VIRGINIA ELECTRIC AND POWER COMPANY  
RICHMOND, VIRGINIA 23261

Serial No.	01-299
SPS-Lic/CGL	R1
Docket Nos.	50-280 50-281
License Nos.	DPR-32 DPR-37

**VIRGINIA ELECTRIC AND POWER COMPANY**  
**SURRY POWER STATION UNITS 1 AND 2**  
**PROPOSED TECHNICAL SPECIFICATION CHANGES**  
**PORV BACKUP AIR SUPPLY OPERABILITY AND**  
**SURVEILLANCE REQUIREMENTS**

**Attachment 1**  
**Discussion of Changes**

**FIGURE 1**

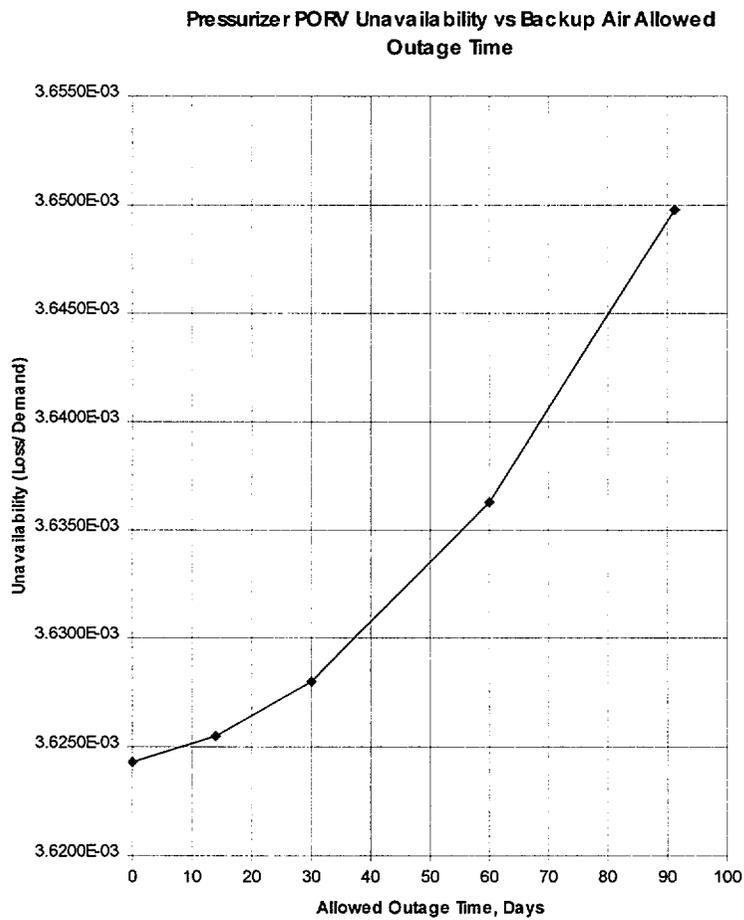
The sensitivity of PORV unavailability to backup air allowed outage time is shown in Figure 1 (below). Since the proposed AOT has negligible impact (less than 0.1%) on PORV unavailability, it follows that the impact of the AOT on the PORV backup air system on core damage frequency (CDF) and large early release frequency (LERF) is negligible.
